Project: **Nebraska Heart Hospital - Hybrid Operating Room Addition**

addendum

addendum no: 2
date: April 20,2012
bid date: April 24, 2012
project name: Nebraska Heart Hospital Hybrid OR Addition
project no: 11216

M301a

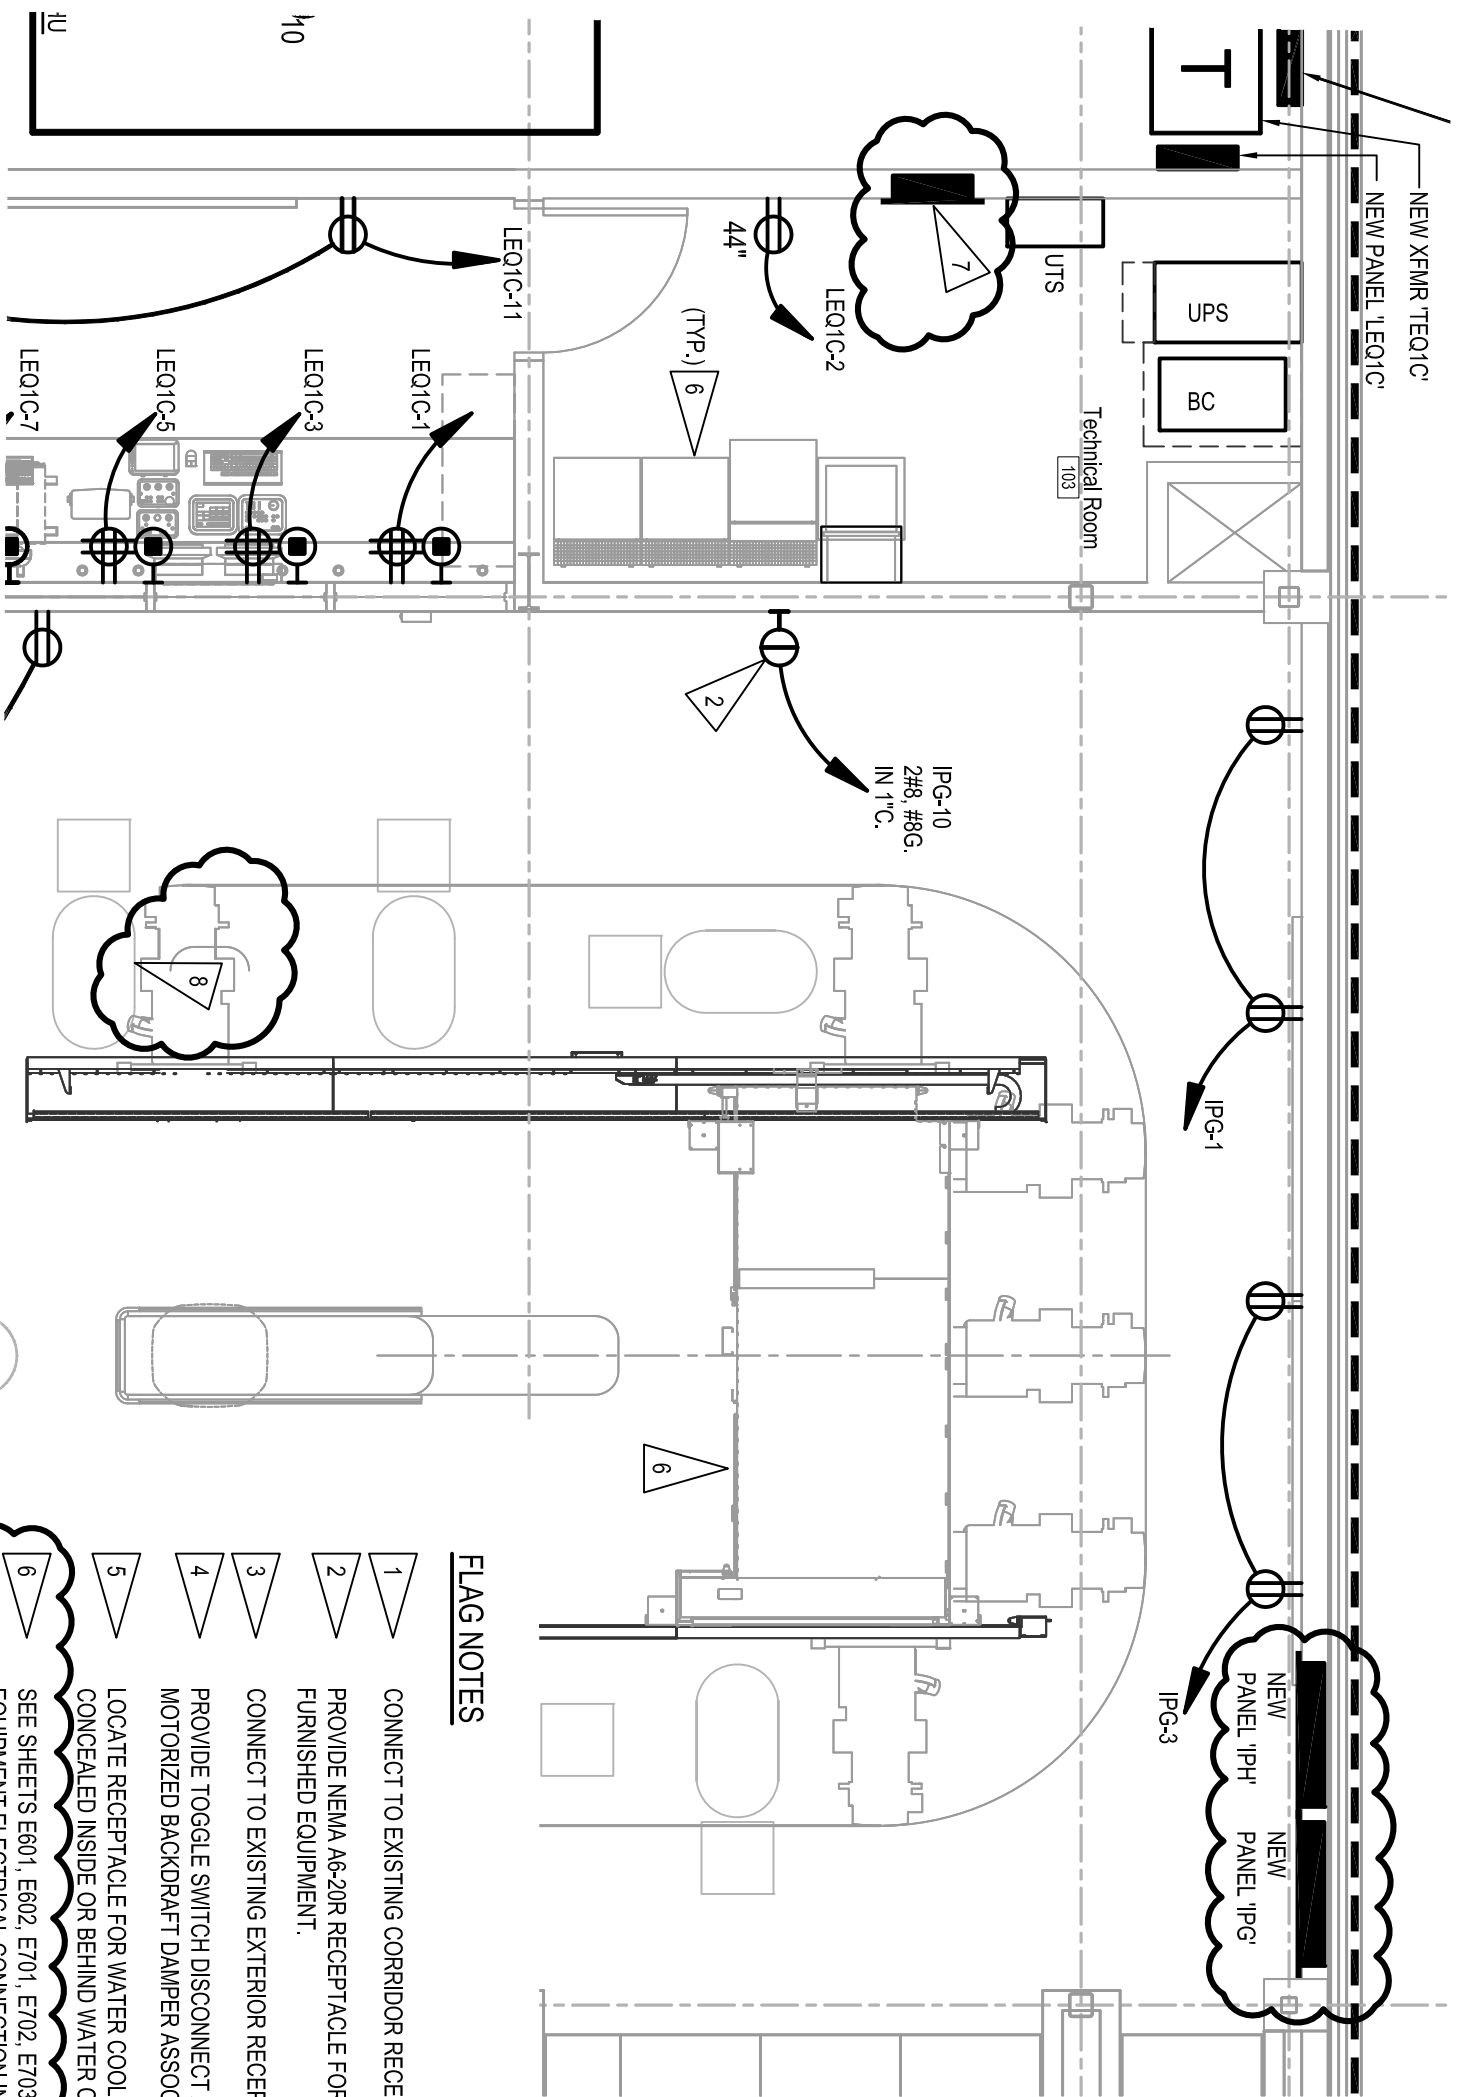
1. Sheet M301 - Med. Gas & Plumbing:
 - a. Add detail reference H11 on Sheet M401 to the medical gases serving Operating Room 100.
 - b. Add vent piping as shown on attached Sketch M301a.

sketch **E201a**

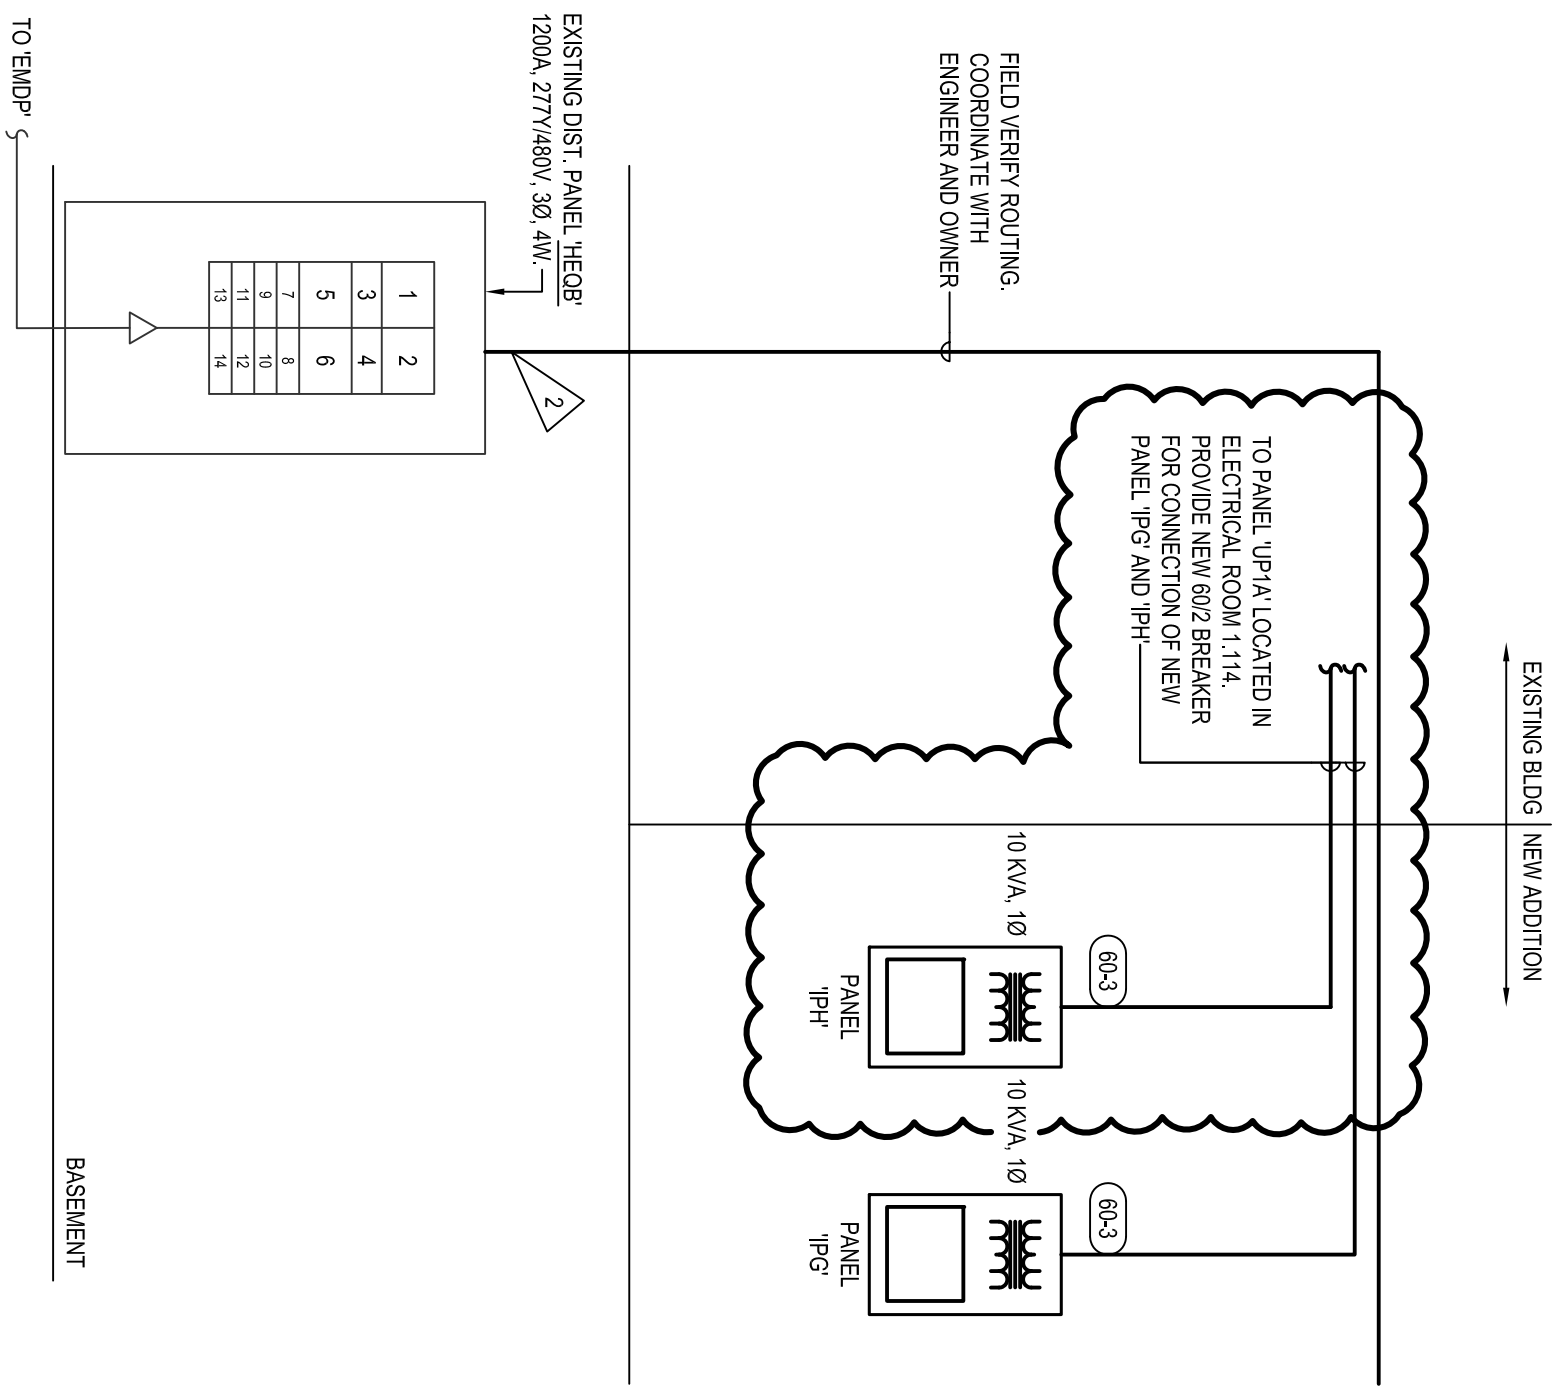
1. Sheet E201 - Floor Plan - Power: Revise per Sketch Sheet E201a.
2. Sheet E501 - Electrical Schedules
Revise per Sketch Sheet E501a.
Lighting Fixture Schedule:
 - i. Kirlin shall be an approved manufacturer for fixture number 2.
 - ii. Fail-Safe shall be an approved manufacturer for fixture number 3.
